Proposal #16: 2590-04-71, WISC 2025314
C Milwaukee W Lisbon Ave
N 100th Street to W Burleigh Avenue
LOC STR
Milwaukee County

This is Addendum No. 01, which provides for the following:

ADDENDUM NO. 01

2590-04-71

Addendum No. 01
ID 2590-04-71
Revised Sheet 22
January 29, 2025

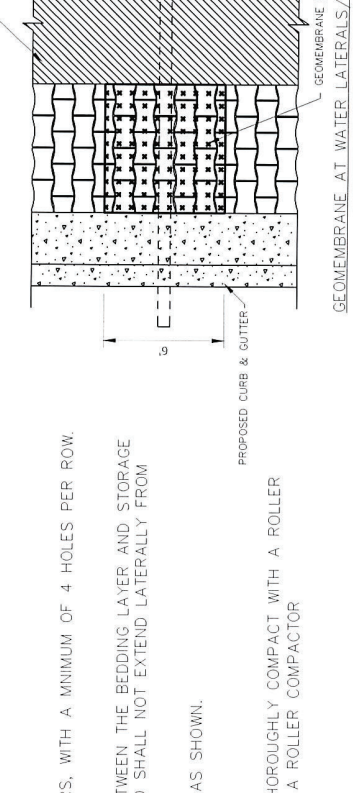
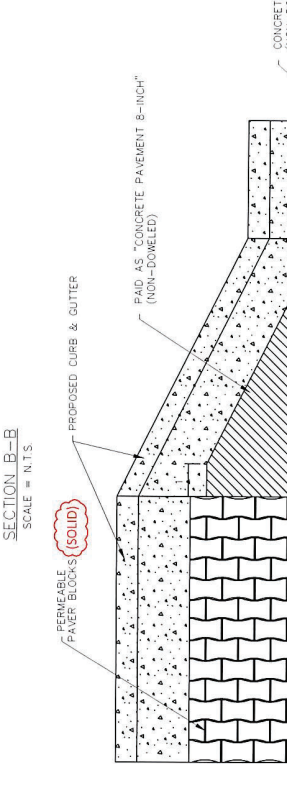
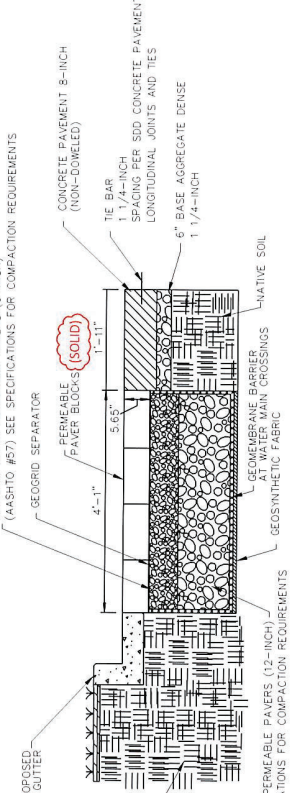
Revised Plan Sheets	
Plan Sheet	Plan Sheet Title (brief description of changes to sheet)
22	CONSTRUCTION DETAILS – Additional construction notes

- NOTES:**
1. THE PIPE UNDERDRAIN SHALL HAVE 3/8-INCH PERFORATIONS, SPACED AT 6-INCH CENTERS, WITH A MINIMUM OF 4 HOLES PER ROW. THE PERFORATIONS SHALL BE DRILLED TO THE BOTTOM SURFACE OF THE PIPE.

2. INSTALL GEOTEXTILE FILTER FABRIC TYPE "DF" ABOVE THE 6" UNDER DRAIN PVC PIPE; BETWEEN THE BEDDING LAYER AND STORAGE LAYER. FILTER FABRIC SHALL COVER AND BE CENTERED OVER THE UNDER DRAIN PIPE AND SHALL NOT EXTEND Laterally FROM EITHER SIDE OF THE PIPE MORE THAN ONE FOOT.

3. INSTALL GEOMEMBRANE BARRIER WITHIN 3' OF ALL EXISTING WATER LATERALS AND MAINS AS SHOWN.
 4. INSTALL STORAGE LAYER IN 4-6" LIFTS AND COMPACT WITH ROLLER COMPACTOR.

5. INSTALL INITIAL BEDDING LAYER STONE IN A 2" LIFT DIRECTLY ON THE STORAGE LAYER. THOROUGHLY COMPACT WITH A ROLLER COMPACTOR. FOLLOWING LAYERS CAN BE INSTALLED IN 4-6" LIFTS AND COMPACTED WITH A ROLLER COMPACTOR.

6. SEE MISCELLANEOUS QUANTITIES FOR PERMEABLE PAVER LIMITS
